ADA Architectural Barriers Summary List

APPENDIX I

TH 1

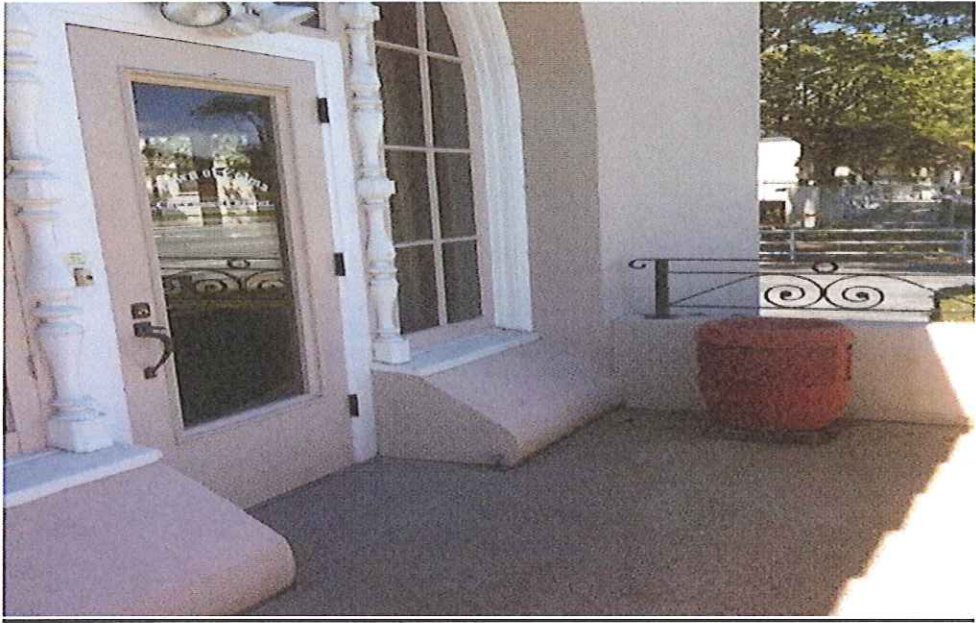
Door to the Council Chambers has inadequate clearance	The ramp will need to be reconstructed to achieve required clearance. Door will need to be widened to get 32" min clear.	H	TH 1, 2	\$125,000	FY2012-13
